RE: *Conditional Zoning Atlas Amendment – Master Plan Development (MPD) for Research Triangle Logistics Park (RTLTP) – First Round Comments*

Attached please find the Applicant's written responses to comments from Orange County issued on June 20, 2020 for the above referenced project.

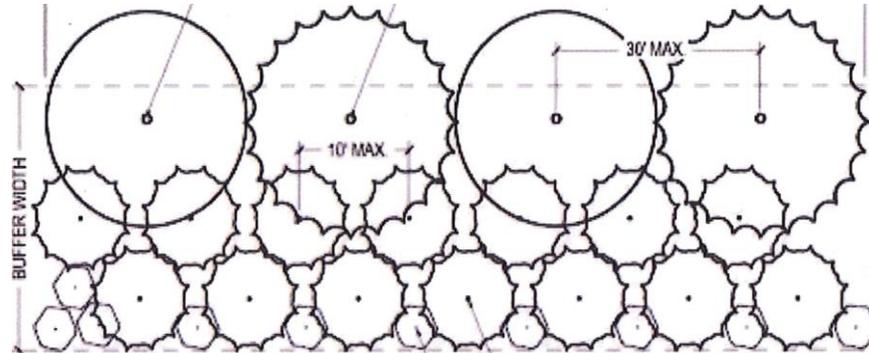
Comment: vii. Sheet C-6 needs a legend detailing what the proposed landscape/buffer areas are.

Further, revise the Sheet to contain the proposed planting schedule (i.e. amount of foliage for every 100 linear ft. of the Project) consistent with previous direction. Staff recommends use of a planting detail on the Sheet supporting this description and offers the following illustrative example as a guide:

Note: not taken from County UDO. Graphic is for illustrative purposes only.

Response: *Planting detail will be added as requested to the master plans*
